CORRIGENDUM #4 DATED 08.05.2021
DESIGN, FABRICATION, SUPPLY, INSTALLATION & COMMISSIONING OF PRESSURE REGULATING SKID
Tender No :AGCL/BD/PMC-GHT/PRS/2020/65 Dated 07.04.2021

ANNEXURE- X

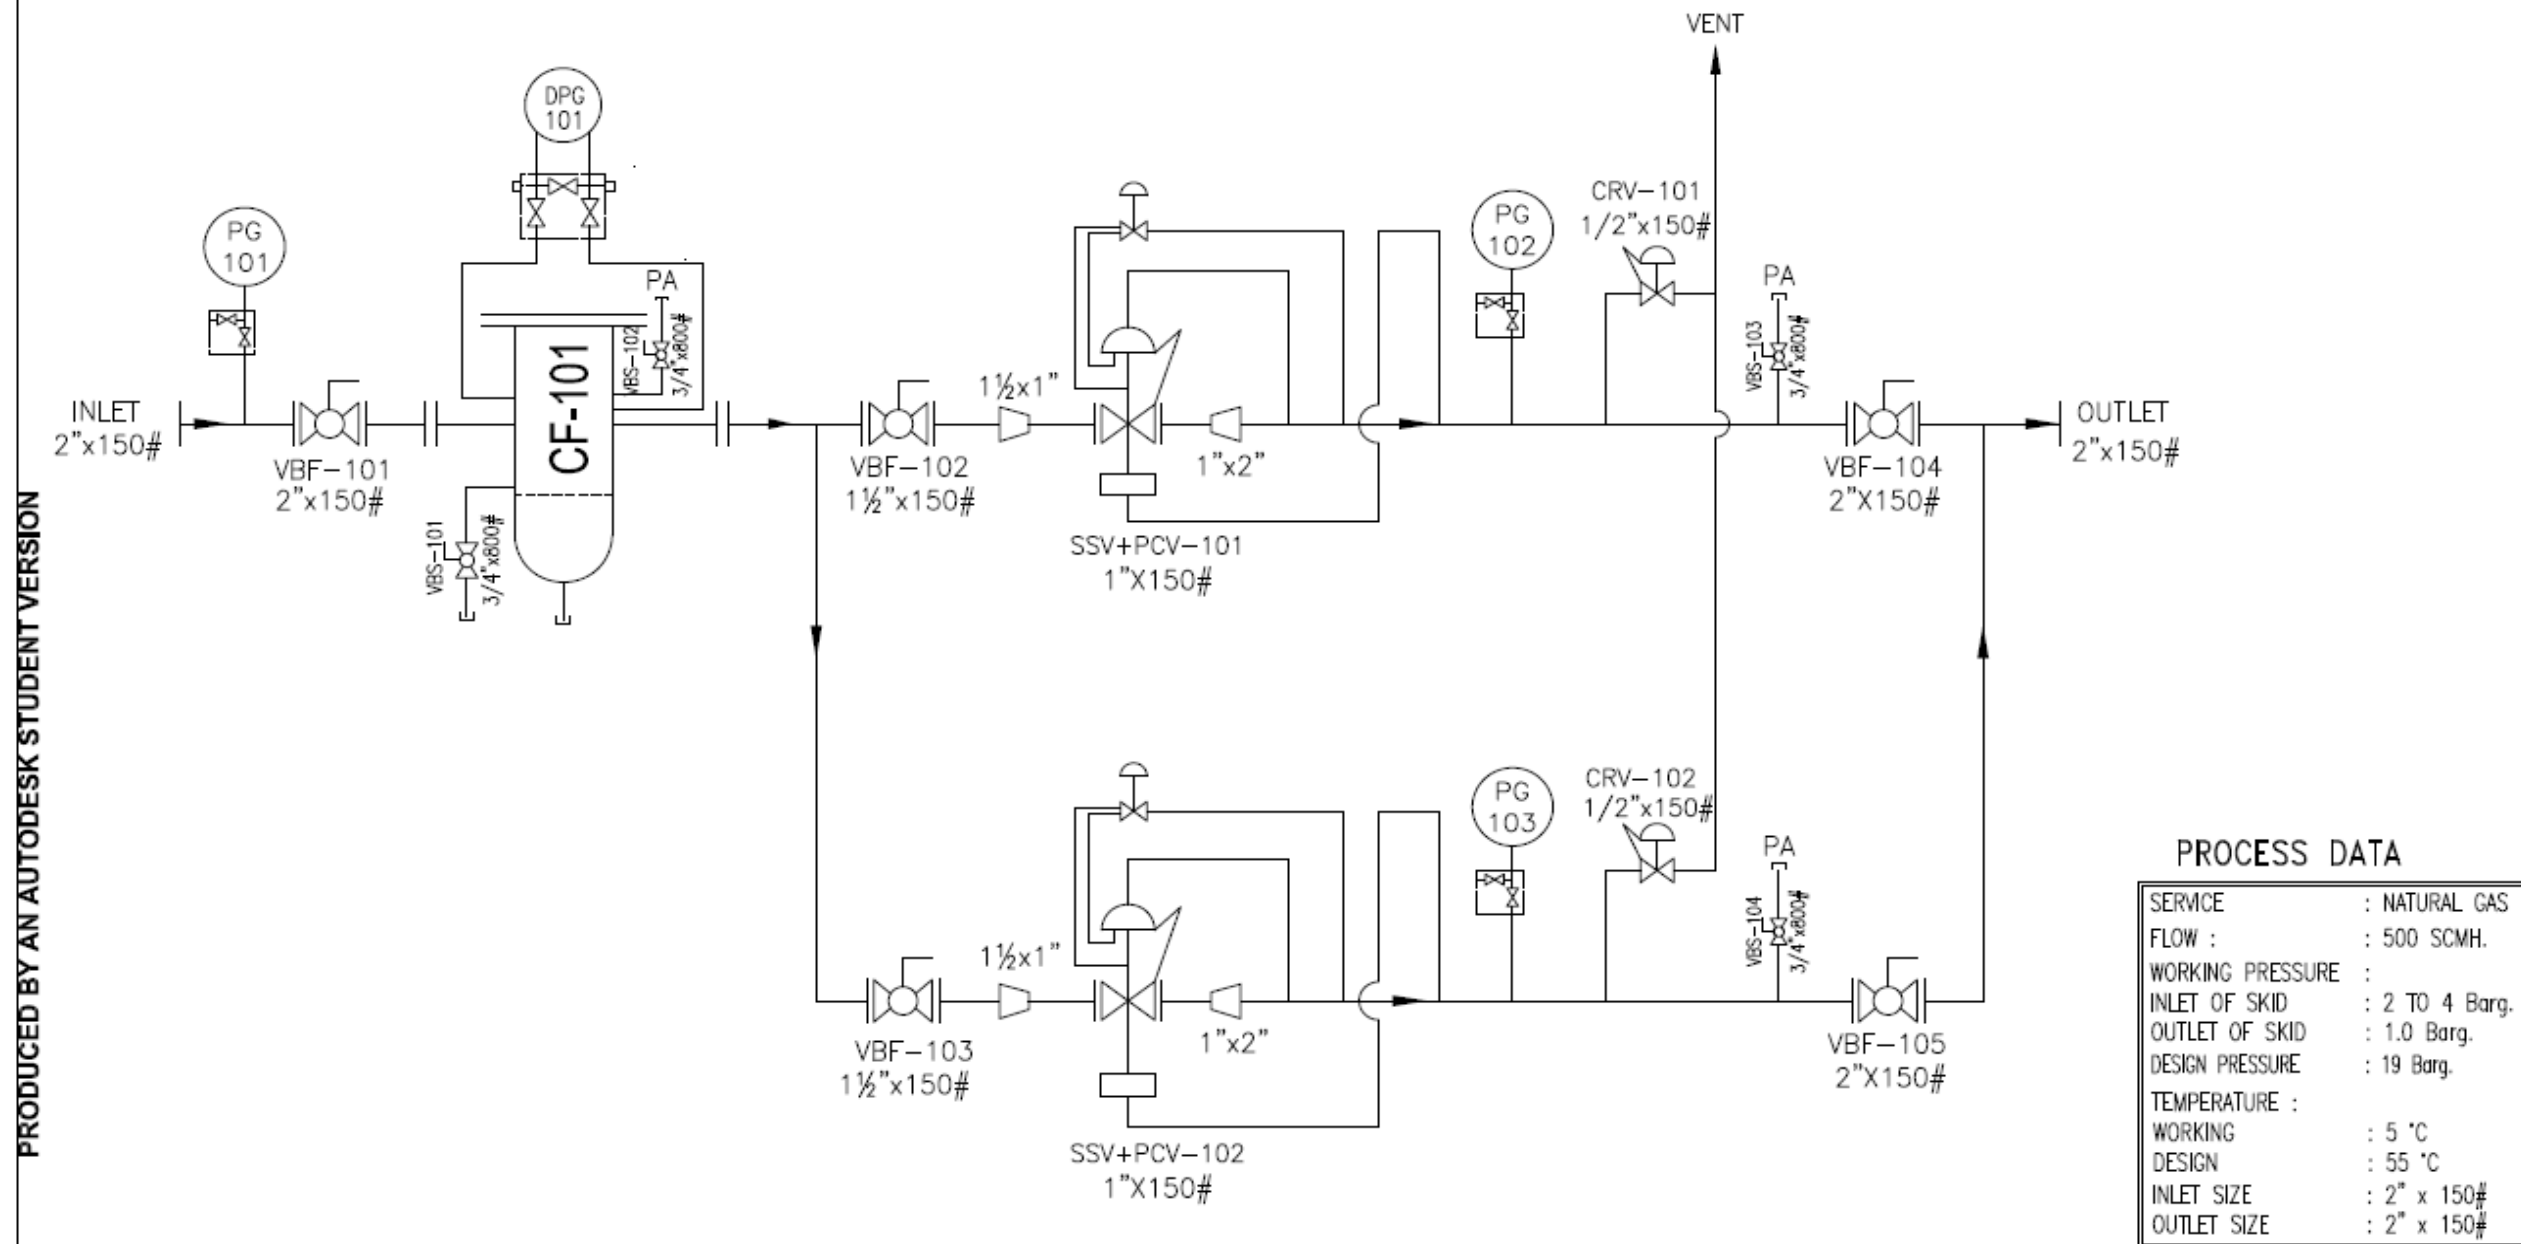
Note: Regulator Sizing shall be done at 0.5 bar outlet pressure. Dp across each regulator shall be 0.2.

Bidder must consider minimum Vessel dia as stated above. However as per bidder, design must select equal or higher vessel dia. Bidder must select Element, Cyclone based on his design.
